Countries: CANADA, UNITED STATES **Document ID:** IK1600189
Availability: ISIS, FleetISIS **Revision:** 2
Major System: CAB / SLEEPER / HOOD **Created:** 9/18/2013
Current Language: English **Last Modified:** 10/15/2013
Other Languages: NONE **Author:** Patrick Gotschall
Viewed: 215

Title: 9900i poor hood fit**Applies To:** 9900i built before 7/22/2013**DESCRIPTION**

Figure 1: Front crossmember should be mounted behind the mega-bracket mounting tabs that are highlighted in the red boxes above.

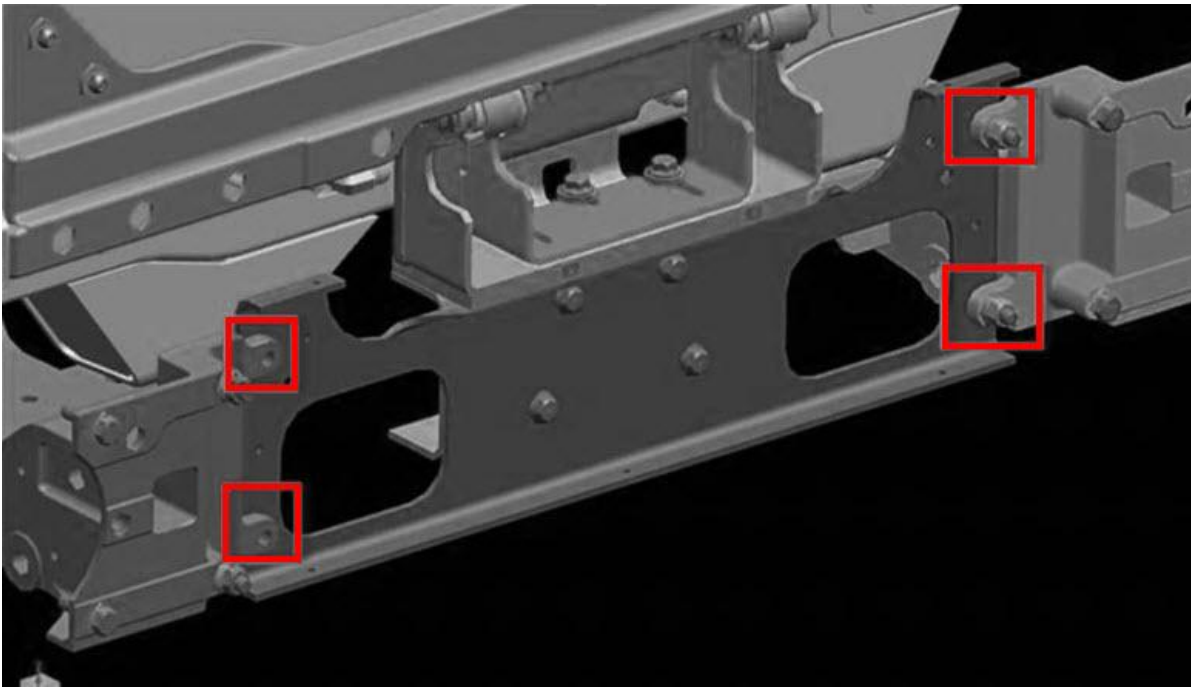
Two issues have been identified in association with poor hood fit on the 9900i. The hood is mounted incorrectly due to improper placement of the front crossmember. The result is that the hood is too far forward resulting in large gaps to the cab and modesty panels. Additionally, with the launch of ISX in June 2013, the hood hinge was redesigned to provide clearance to the new cooling package. However, some trucks were built with the incorrect (older) hinge. No interference would be observed because the hood is positioned too far forward. Once the cross-member position is corrected, trucks built with the older hinge will have an interference condition with the cooling package, so the old hing needs to be swapped with the new hinge (3565264C3).

1. The front cross-member was positioned incorrectly from an unknown start date until 7/18/2013.
2. The incorrect hood hinge was used on some trucks starting with the implementation of Cummins ISX on 6/11/2013 through 7/21/2013.

1. Inspect the front cross-member.
2. If it is mounted to the rear of the mega-brackets as shown in Figure 1, it is mounted correctly. Move to step 7.
3. If it is mounted to the front of the mega-brackets, it is mounted incorrectly.

5. Disassemble and reassemble the cross-member such that it's in the position as shown in Figure 1.
6. If the truck was built prior to 6/11/2013, reattach the hood. The job is complete.

Figure 3: New hinge (3565264C3)
Arrows point to areas that are different from the old hinge.

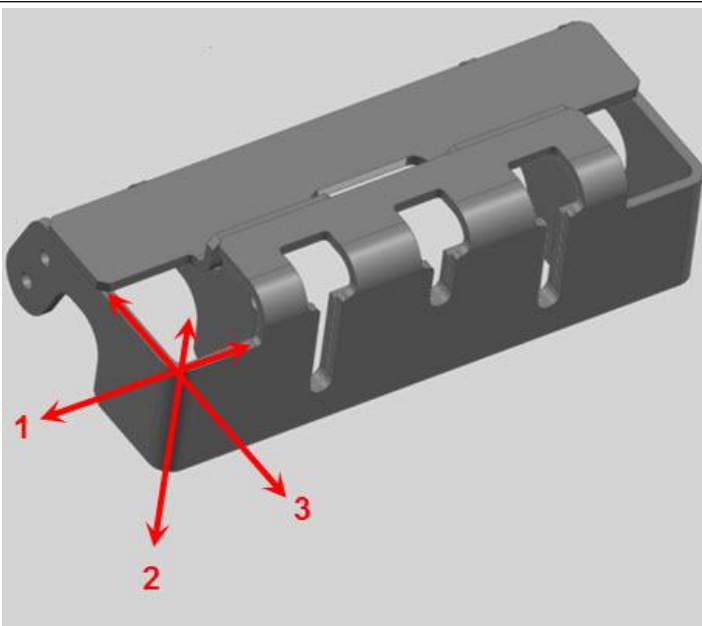
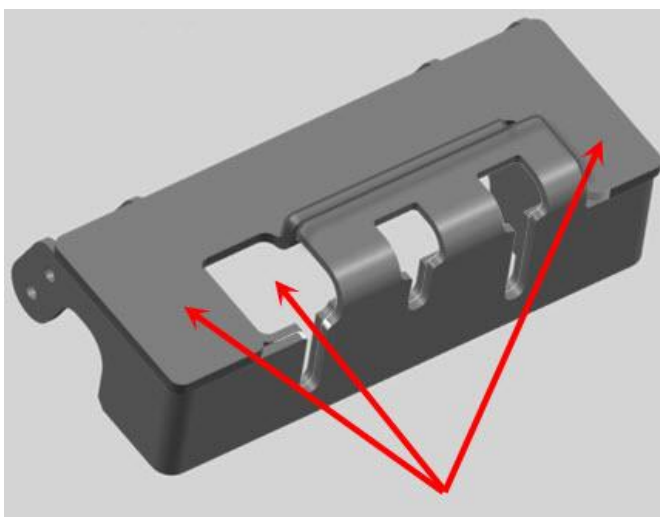
7. If the truck was built on 6/11/2013 or later, inspect the hood hinge.
8. Refer to Figures 2 and 3 to determine if it is the old or new hinge.
9. If it is the new hinge, reattach the hood. The job is complete.

10. If it is the old hinge, replace the old hinge with the new hinge (P/N 3565264C3).
11. Reattach the hood, the job is complete.
